Subject: Check of the safety of the aileron hinge pins.

Applicability: All ASW 28, LBA - Document No. 423, Serial Number 28001 through 28029, except for 28001, 28008, 28023, 28025, 28026 and 28028, which are already checked.
From serial number 28030 onwards appropriate checks were done prior to delivery.

Fig. 1 QR-Antriebslager / aileron actuator
Bolzen mit kl. Kopf / Clevis pin

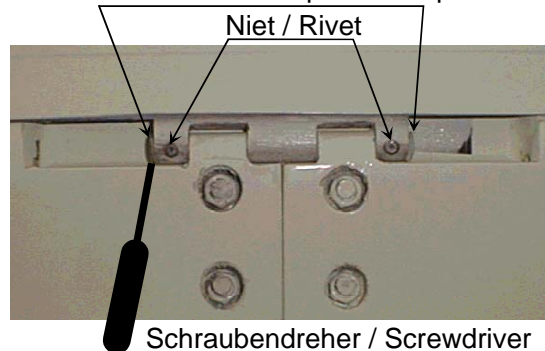
Reason: During an annual inspection loose safety rivets were found, which secure the aileron hinge pins. There is the danger, that some hinge pins may move in span direction, so that they may be pushed out of the hinge in a worst case.

Action: **1)** For inspection of the aileron hinges the Mylar cover on the lower wing surface must be carefully lifted. The sealing Teflon tape underneath must be cut in flight direction with a sharp knife between the head of the clevis pin and the wing side hinge fitting, just big enough, that a screw driver can be entered between pin head and fitting and when entering is possible, by rotation of the screwdriver attempting to move the pin in span direction. Check at the same time, if the safety rivet is loose (see Fig. 1 & 2).
When the screwdriver can not be entered and the safety rivet is tightly in place, no further action is necessary.
When all hinge pins can not be moved, the ASW 28 can be put back to operation. The small cuts in the Teflon tape can be sealed by some grease and the elastic Mylar cover must not be distorted.

2) Loose and/or not correctly engaging safety rivets must be exchanged against new blind rivets with flat round head (= Flachrundkopf in German) of the dimension diameter 2,4mm x 5 mm long, according to DIN 7337 A to secure the hinge pin. During setting the rivets apply some force to the rivets, so that they are additionally pushed into the holes. Reset the tool when necessary. Check the hinge pin and safety rivet. Now apply a new Teflon sealing tape as well as a new Mylar cover as it may have been damaged too much. Partial replacement in sections is possible.
